# Access Compliance Report

## Public Rights-of-Way

### (Pedestrian Signals)

Intersection ID: N/A	Main Street:	Cross Street: N/A	Location: N/A
ADA ID: 6E0B8D3EDCDD	Signal Type: One Push Button-APS	Overall Compliance: No	Severity Score: BTN 1: N/A BTN 2: N/A No BTN: N/A
Codes/Mitigation Info/Possible Solution		Field Measurements/Component Compliance

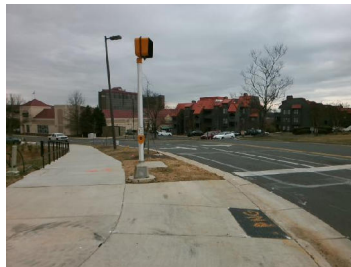
Surveyor Notes: STILL NOT HOOKED UP,  
NOISES , VERBAL NOTICES UNKNOWN

PROW/ADA: R404.2, R404.7.3, R404.7.2,  
MUTCD 4e.08, R104.2, R209.1,

Possible Solutions: Remove & Replace  
Replace APS Button With New APS Button.  
Remove and Replace Clear Space.
